# SUBMISSION TO SYDNEY OLYMPIC PARK MASTER PLAN 2030 (2016 REVIEW) AND STATE SIGNIFICANT PRECINCTS SEPP AMENDMENT

We write on behalf of Mirvac Projects Pty Ltd to provide a submission to the Sydney Olympic Park Master Plan 2030 (2016 Review) and the associated amendments to *State Environmental Planning Policy (State Significant Precincts)* 2005.

Figure 2 - Central Precinct Building Heights Plan

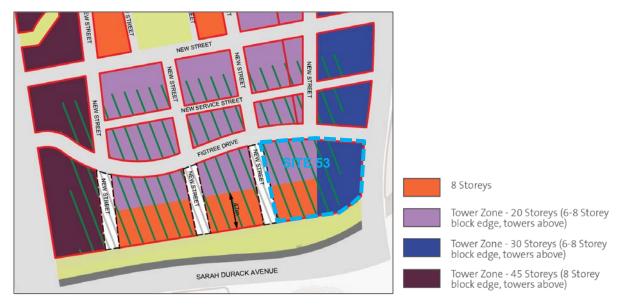
The draft amendment to SEPP State Significant Precincts 2005 specifies three maximum height of building standards applicable to Site 53, including 33m, 74m and 102m. The 2016 Review translates these maximum height of building standards to heights in storeys as follows (refer Figure 2):

Given the highly constrained nature of Site 53 it is our opinion that the allocation of six different height of building standards across the site is unreasonable and unnecessary. As shown on Figure 5.9 Central Precinct Building Zones and Setbacks Plan of the 2016 Review, Site 53 is required to provide a 20m view corridor which splits the site in two, the retention of three existing significant Fig Trees, a large publicly accessible landscaped urban forecourt on the corner of Australia Avenue, and half of 'New Street' along the western boundary (refer Figure 3).

It is our opinion that the maximum height of building controls, when combined with the site-specific requirements of the 2016 Review, restrict the future development potential of this significant gateway site at the entrance to Sydney Olympic Park.

**Recommendation 3:** It is recommended that the draft amendment to SEPP State Significant Precincts 2015 be revised to allow for a maximum building height of 120m on Site 53, in order to deliver an 'entry gateway' to Sydney Olympic Park. Further, it is recommended that various maximum building heights specified across Site 53 be reconsidered to allow for a greater flexibility in building design and height transition across the site and precinct.

Figure 3 – Central Precinct Building Zones and Setbacks Plan

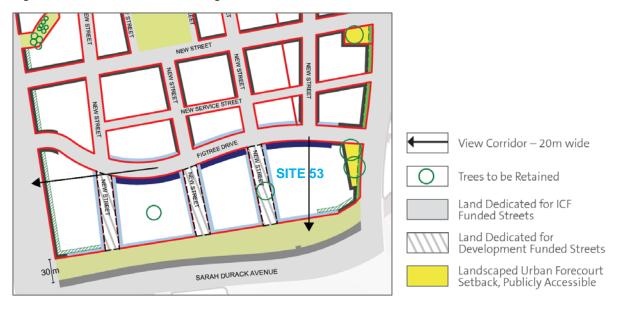
Site 53 must also accommodate a 'no-throw-zone' setback to the Olympic Park Railway Line and a large easement on the southern boundary. These site-specific requirements significantly reduce the amount of 'developable' land within Site 53.

Furthermore, the requirement for 6-8 storey block edge with towers above on Site 53 and across the entirety of the Central Precinct will create a monotonous built form and urban design outcome and will impact on the ability for future development to achieve compliance with the residential amenity requirements of the Apartment Design Guide and the 2016 Review. This form is likely to cause overshading of the public domain and adjacent properties, as well as visual and acoustic privacy concerns.

Figure 4 - Central Precinct Land Uses Plan

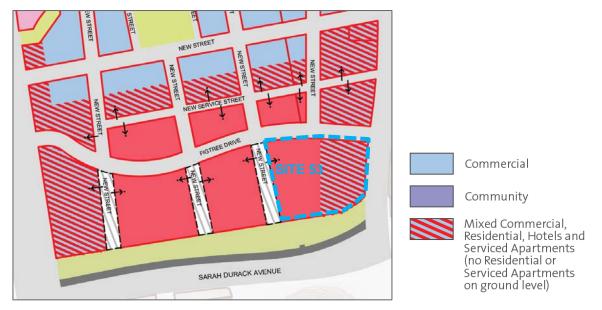
Section 5.2.4 of the 2016 Review provides Land Use Controls applicable to the Central Precinct. Figure 5.7 Central Precinct Land Uses Plan specifies 'Mixed Commercial, Residential, Hotels and Serviced Apartments' land uses for the eastern portion of Site 53, and states no Residential or Serviced Apartments are permitted on ground level.

The location, orientation and design of the retail lot was developed as part of the Design Excellence Competition for Site 53 and has been the subject of extensive design development and consultation with SOPA and the Design Review Panel. The requirement for a double height retail frontage and double height colonnade on Australia Avenue is inconsistent with the agreed design for the retail lot on Site 53.

Furthermore, there is a significant change in height across the eastern boundary of the site, from a high point in the north-east corner to a low point in the south-east corner. This significant change in level limits the opportunity to provide a single level retail lot across the eastern portion of the site.

**Recommendation 4:** It is recommended that the 2016 Review be amended to remove the requirement for no Residential on ground level across the eastern portion of the site, and double height active frontage and two-storey colonnade on Australia Avenue to allow for the future development of a single level supermarket, in accordance with the Project Delivery Agreement.
